**Review of Sandia National Laboratories'
Mixed Waste Landfill Corrective Measure Implementation Plan
and Fate and Transport Model:**

Comments and Recommendations

February 7, 2006

Prepared on behalf of:
Citizen Action New Mexico

Figure 22. Simulated PCE groundwater concentrations for 100 realizations.

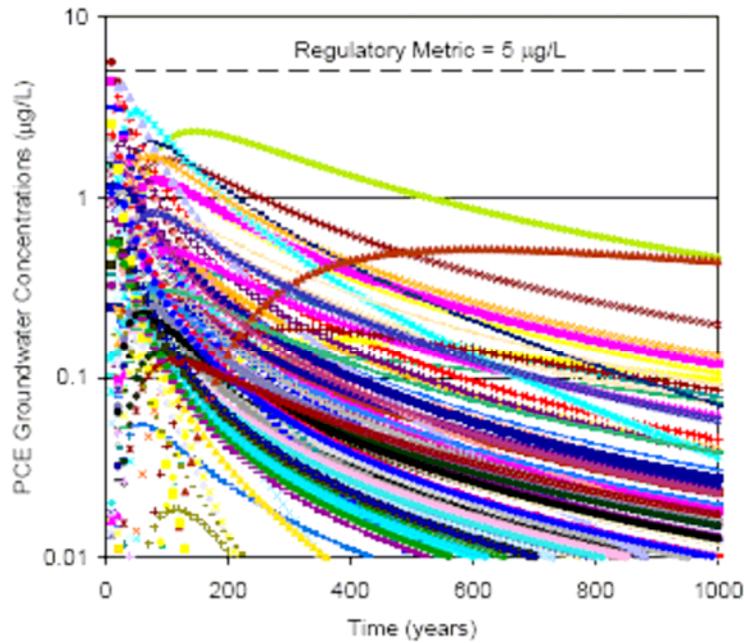
“Figure 22 [on p. 55] shows the simulated PCE concentrations in the groundwater as a function of time for all 100 realizations. **The majority of the realizations show the aquifer concentrations peaking before 50 years. Depending on the time of disposal, this corresponds to peak concentrations occurring by 2010 – 2040.** [emphasis added]. To date, no detectable amounts of PCE have been found in the groundwater at the MWL. This is still consistent with the simulations which show a large amount of variability in the simulated concentrations resulting from uncertainty included in the input parameters.” FTM at pp. 54-55. Figure 22 is attached these comments as APPENDIX A.

Thus, the FTM confirms that a volatile organic compound already shown to have escaped from the MWL, tetrachloroethylene (PCE), is likely to reach the groundwater aquifer within 50 years in most model runs. This finding should serve as a basis for NMED to focus a substantially higher degree of attention on the need for a corrective measure at the MWL that can be demonstrated to effectively control releases of VOCs.

RECOMMENDATION: Because PCE was shown to reach groundwater in all model realizations within approximately 50 years, the FTM should be revised to include model realizations reflecting future movement of all VOCs and SVOCs found to have been released from the landfill in 1993. These additional models and model realizations should be revised to include consideration of the decay products of PCE and the other VOCs and SVOCs that were shown to have escaped the MWL by 1993. Decay products modeled should include any decay products, such as vinyl chloride, that may have MCLs as low or lower than that established for PCE.

Figure 23. Cumulative probability for simulated PCE peak groundwater concentrations for 100 realizations.

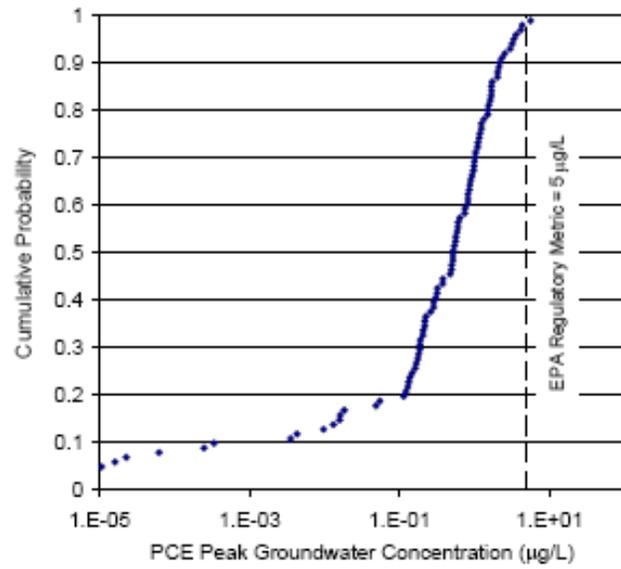
Figure 23 in the FTM shows the concentration of PCE anticipated in the groundwater by the model realizations. This figure shows that the vast majority of the realizations – about 80% - show PCE levels in the groundwater in the range of 1 – 5 micrograms per liter, equivalent to parts per billion. Prediction of those concentrations of PCE reaching the groundwater represent a prediction of significant contamination as PCE is not naturally occurring and therefore **zero** PCE would be predicted to have reached groundwater if no PCE were already shown to have escaped from the MWL. Figure 23 is attached to these comments in APPENDIX A.
